Our Ref: N0241372-CLTR-01A

Project: Class 2 Mixed-use Project

Address: 37 Archer Street
Chatswood NSW 2067

Appendix A – 37 Archer Street Comments Register

GROUND FLOOR STORMWATER PLAN
SCALE 1:100

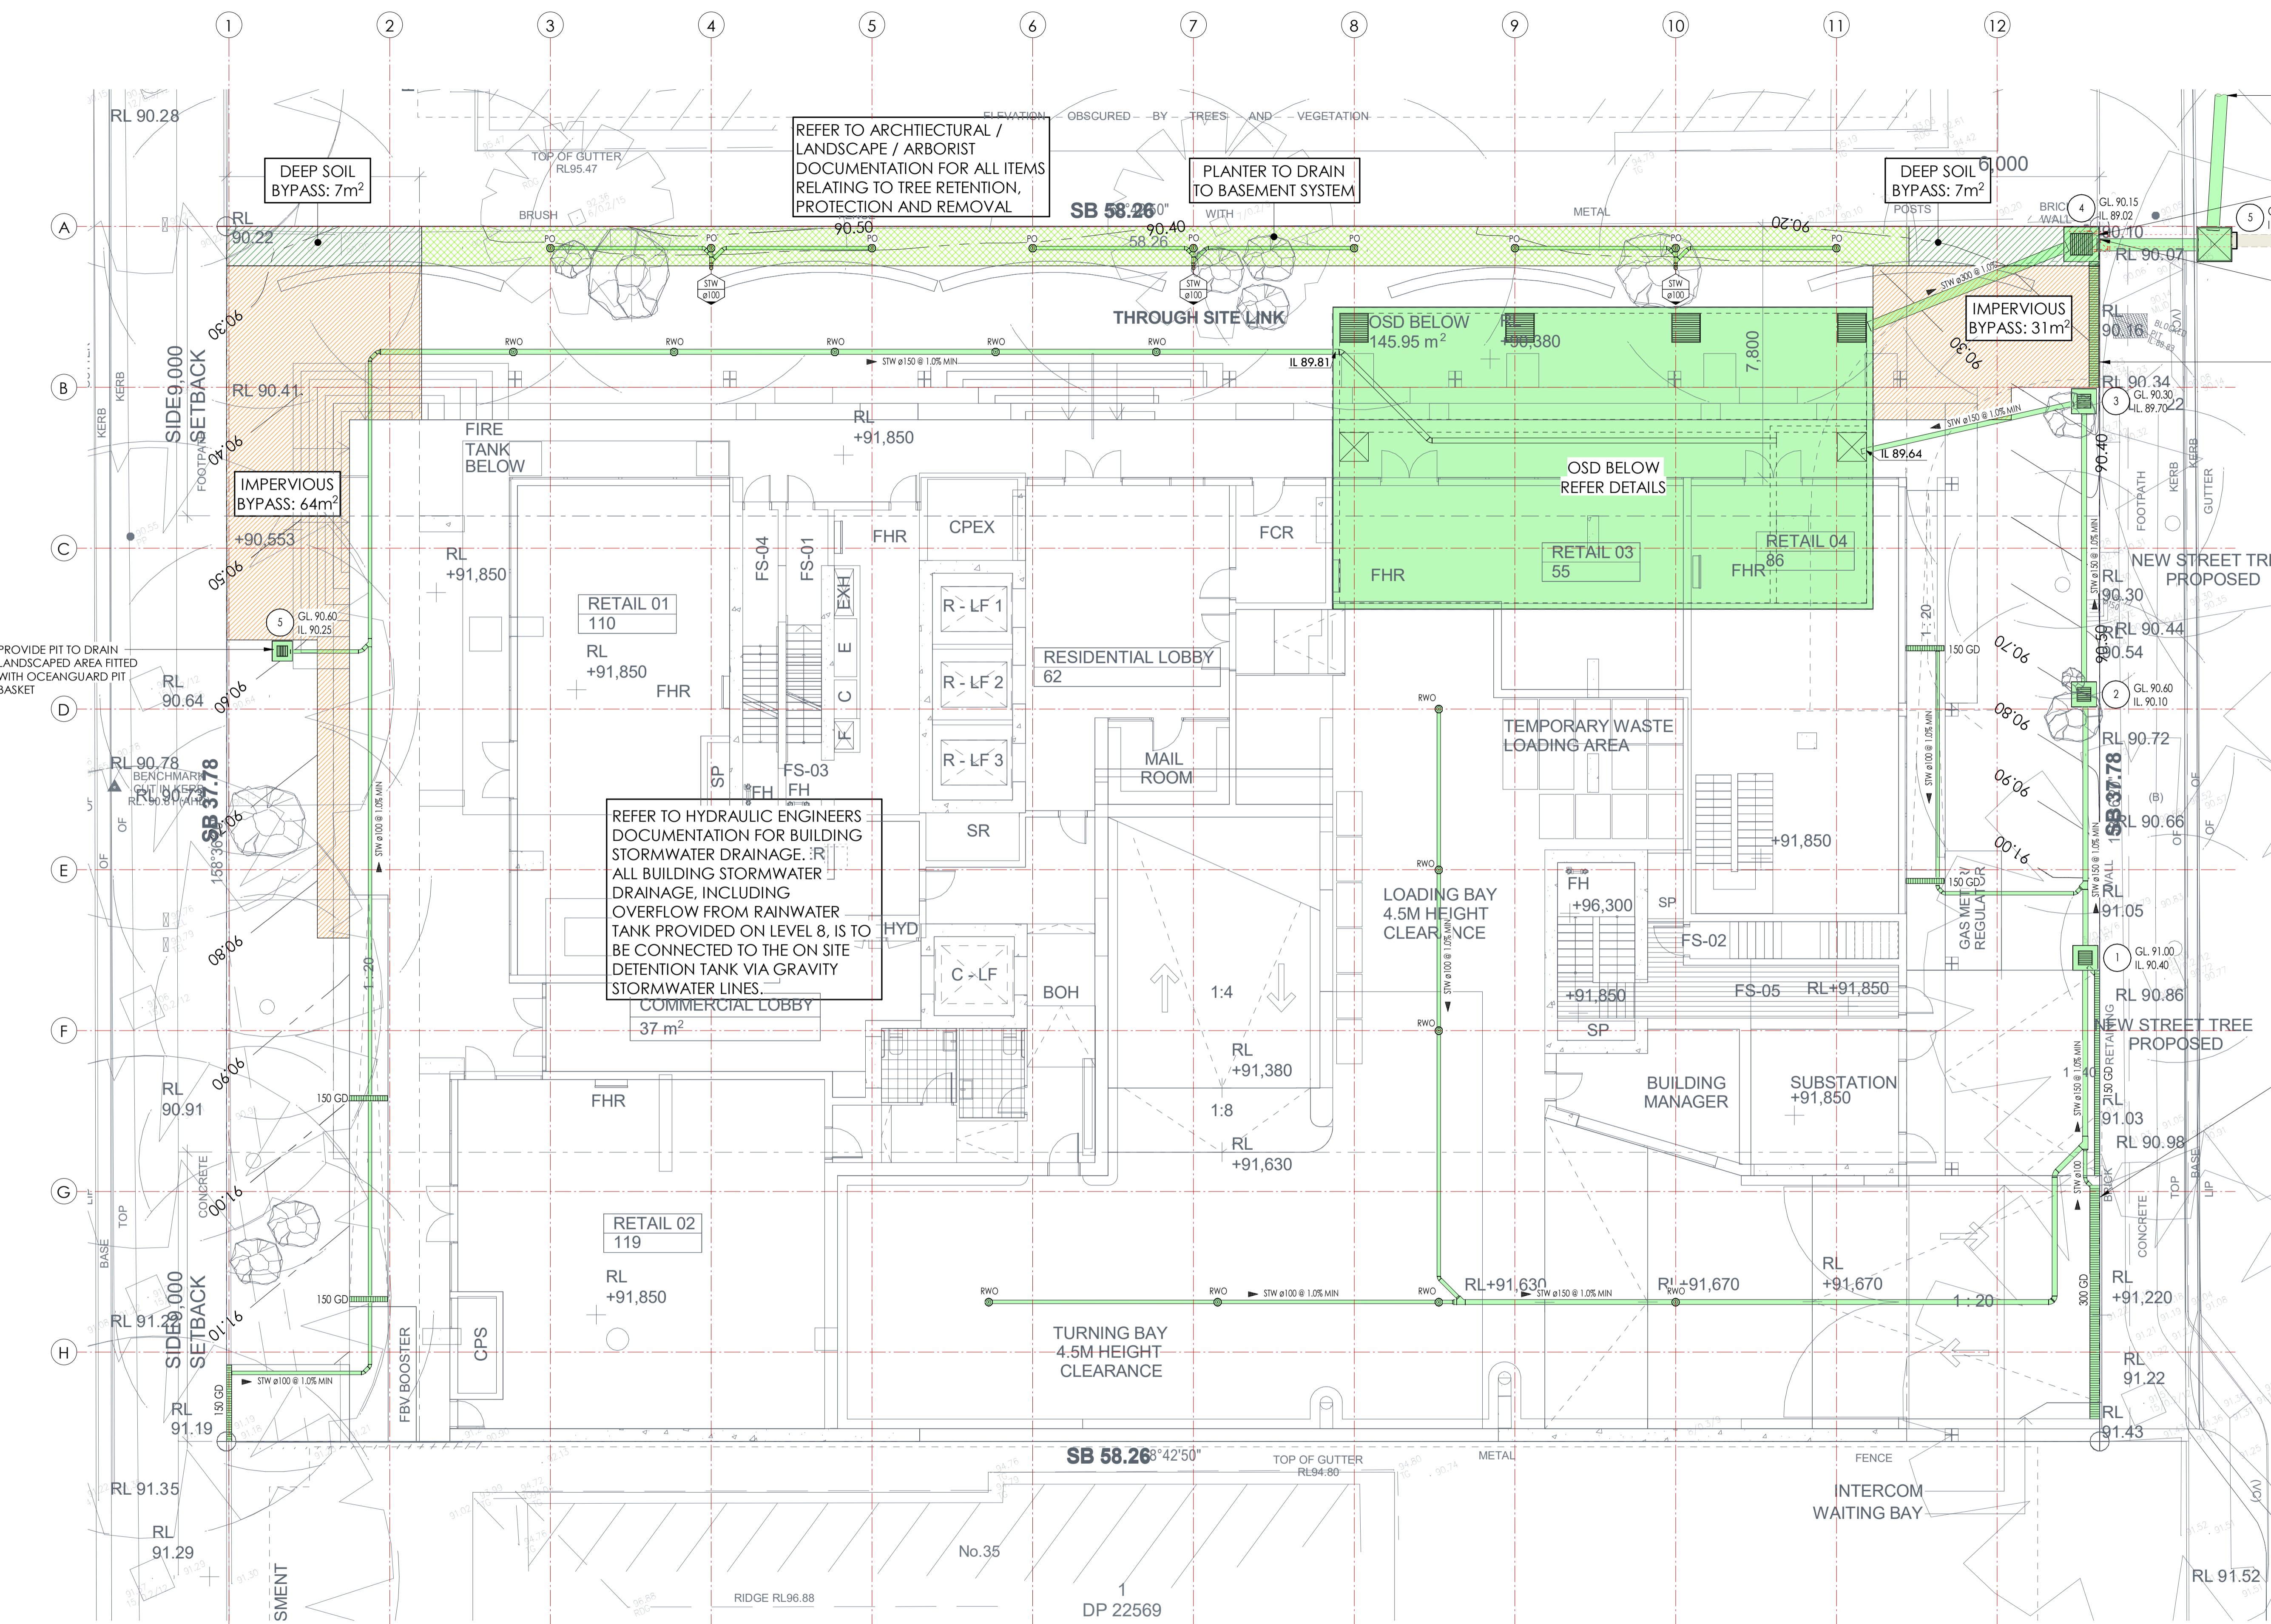
5	Section d) Stormwater Management of	Willoughby City Council	Access points to the OSD tank are generally location on one site only. To allow for cross-ventilation, safe	Access grates are located in the northern corners of the OSD tank, as well as over the outlet.	Drawing N0241372 C054 and C200.

Attachment 1 – Council Submission		<p>access to the tank and to minimise the need to enter the tank, access points should be located at all corners of the tank, and as a minimum over the outlet and the diagonally opposite corner. To ensure that access is available at all times, particularly for emergency maintenance, all access points to the tank need to be located in common areas and not in tenancies. The plans are not clear that this is achieved. The architectural plans should be amended to show the location of the OSD tank and all access points to the tank.</p>	<p>Access grates cannot be placed in the south-east and south-west corners of the OSD tank as these points are located within retail tenancies.</p> <p>All proposed access points to the OSD are in common areas and not in tenancies.</p> <p>Civil plans show updated OSD access points for coordination with architects.</p>	
6	Section d) Stormwater Management of Attachment 1 – Council Submission	Willoughby City Council	<p>As the tank is not located in a position where flows in excess of the capacity of the pipe network can drain to the OSD tank, the internal pipe network needs to be designed to cater for the flow from the 1%AEP event.</p>	<p>Internal pipe network has been designed and sized for flow from the 1% AEP storm event.</p>	Drawing N0241372 C200.

BERTRAM STREET STORMWATER PLAN
SCALE 1 : 100

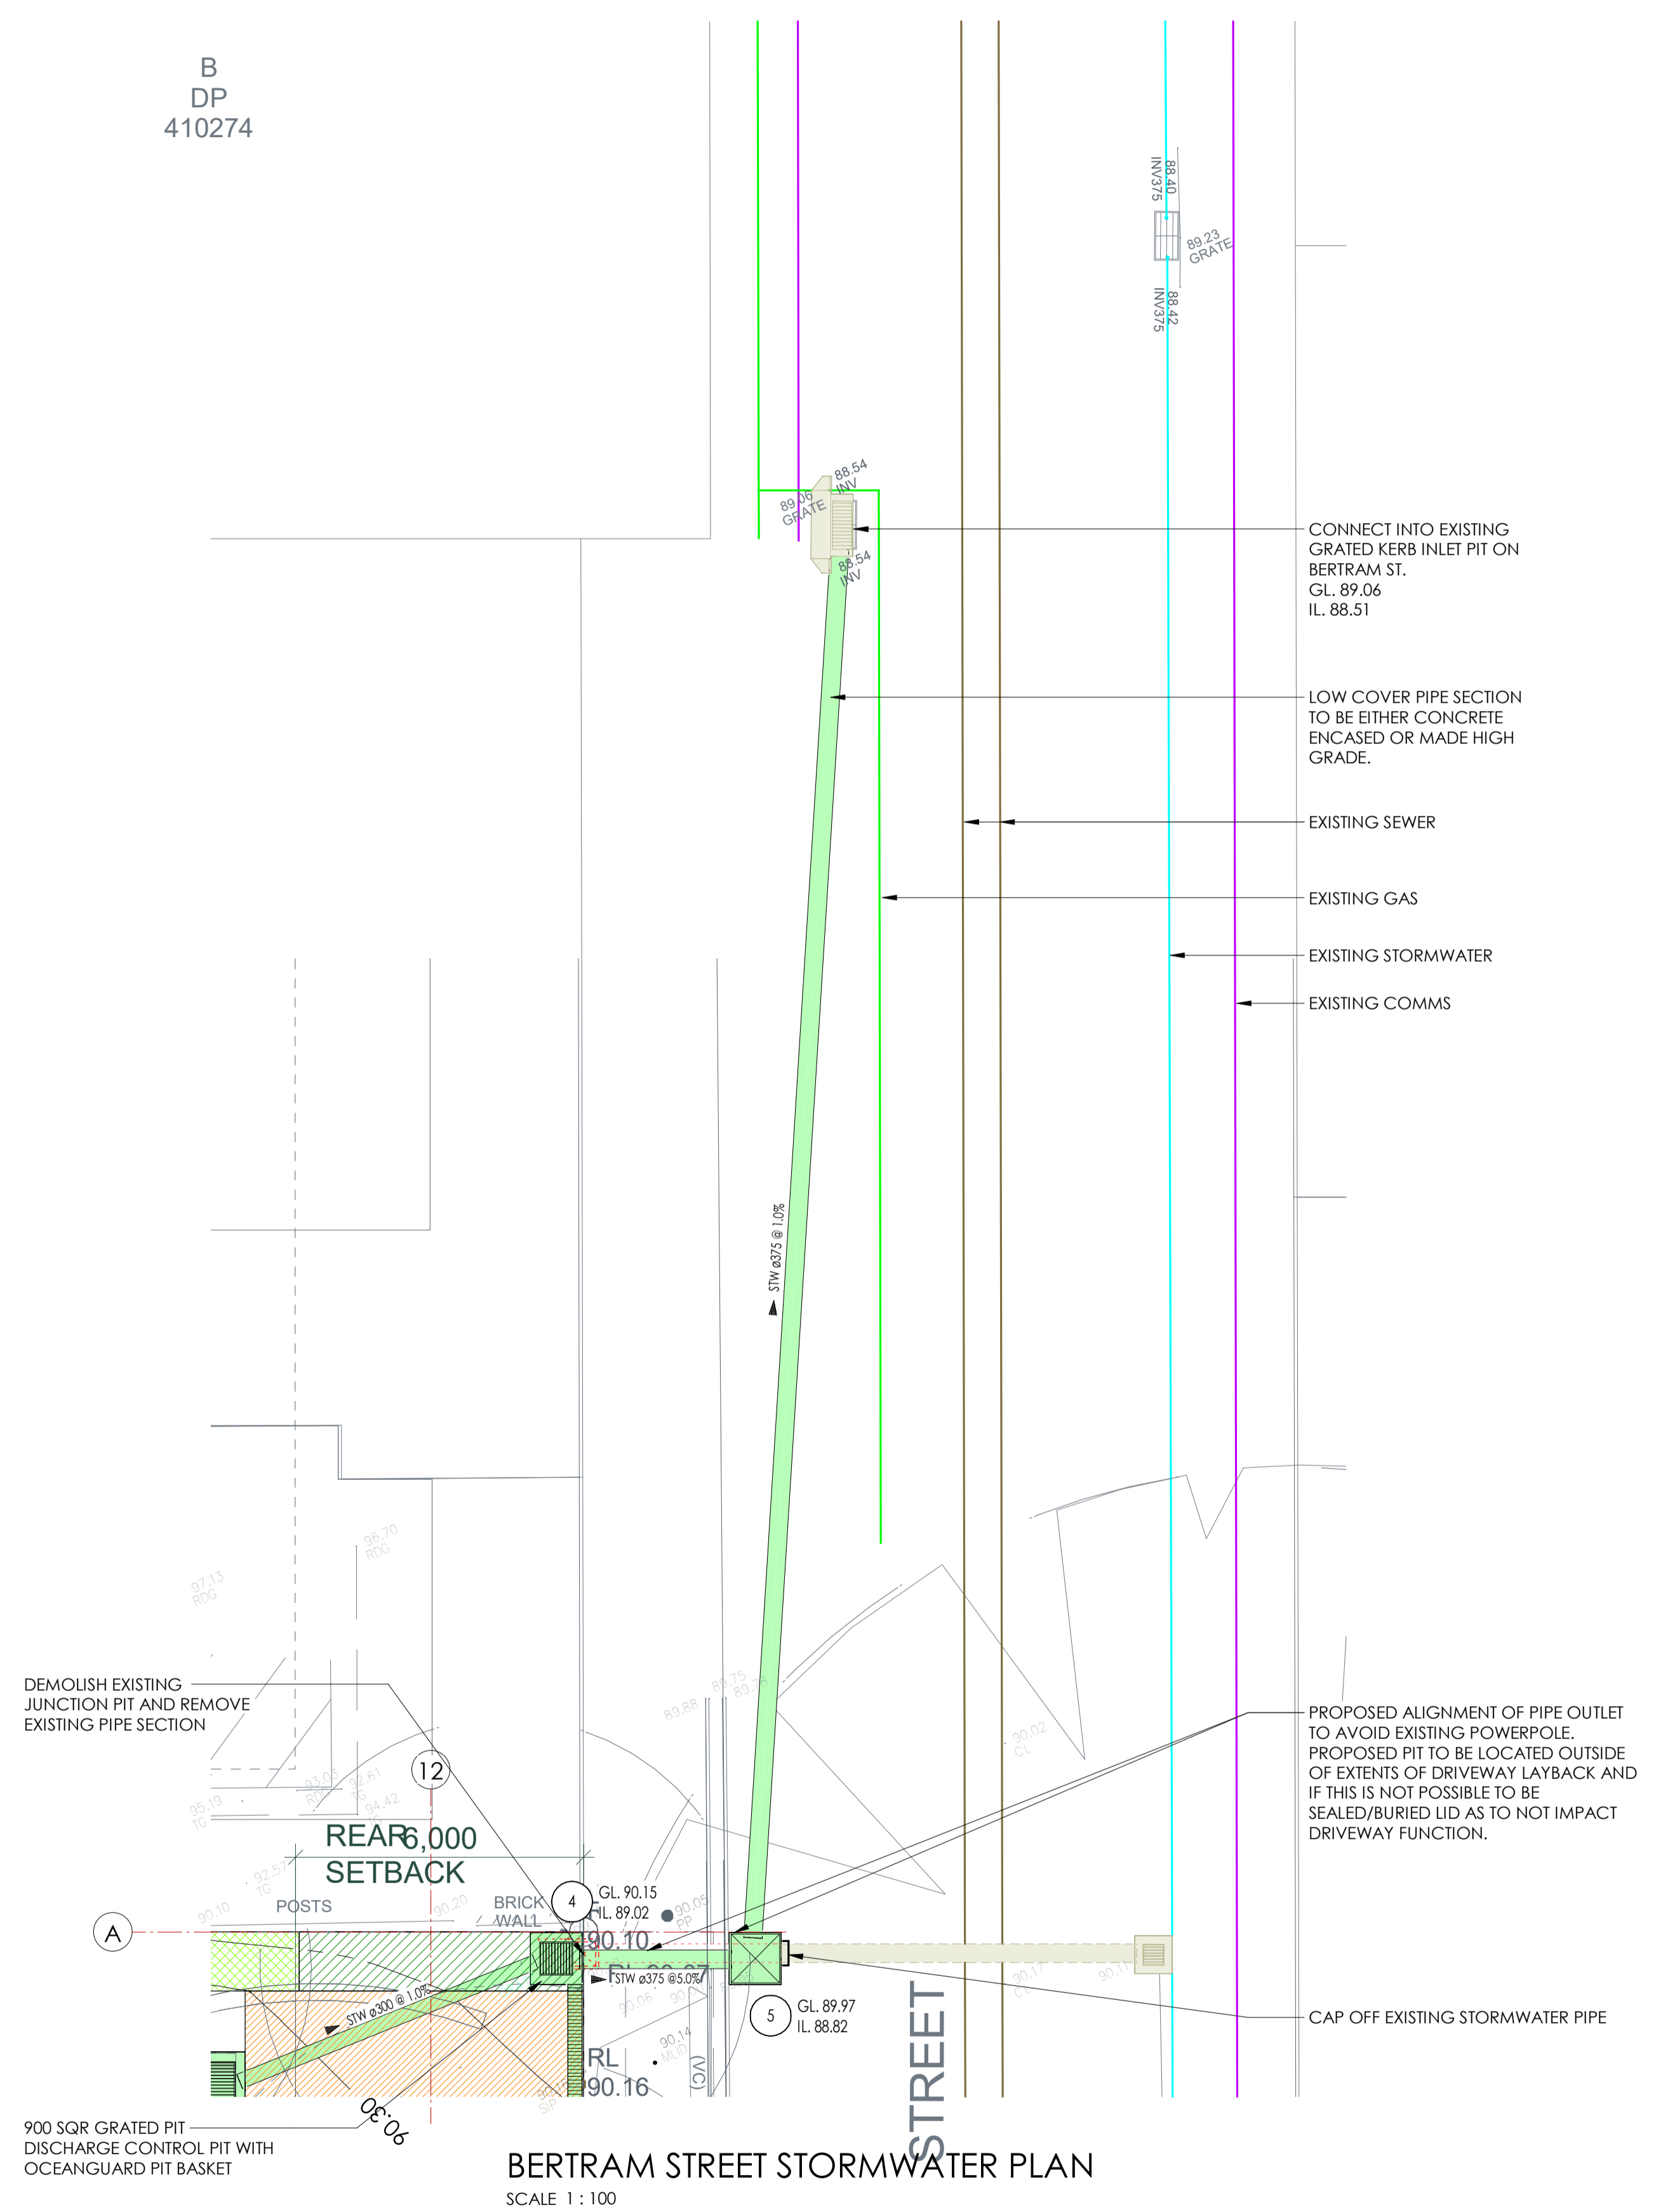
4	Section d) Stormwater Management of Attachment 1 – Council Submission	Willoughby City Council	The stormwater management plans include an on-site stormwater detention system and water quality improvement system as required by Council's Technical Standard 1. However, there are	Outlet of the OSD tank is above the downstream 1% AEP water level. Refer to Appendix B of this report, for longitudinal section of the proposed drainage line	Drawing N0241372 C205.

<p>elements of the system that do not comply with Council's requirements and will impact the operation of the system.</p> <p>As the system is required to be designed to cater for storms up to the 1%AEP event, the tank needs to be located at a level where the outlet of the tank is above the downstream 1%AEP water level. This is required to ensure that the tank outlet is not impacted by the downstream water level, which will impact the operation of the orifice / outlet. In order to demonstrate that the tank is not impacted by the downstream water level, a longitudinal section needs to be provided from the connection point to the Council system to the outlet of the OSD tank. The section needs to include a hydraulic grade line analysis, with the adopted downstream water level the 1%AEP water level as per the Flood Impact Report prepared for the development.</p>	<p>(including hydraulic grade line analysis), from the OSD tank outlet to Council's existing drainage system on Bertram Street.</p> <p>1% AEP water level at the point of OSD connection to Council's existing drainage infrastructure, has been adopted as per the Flood Impact Report.</p>
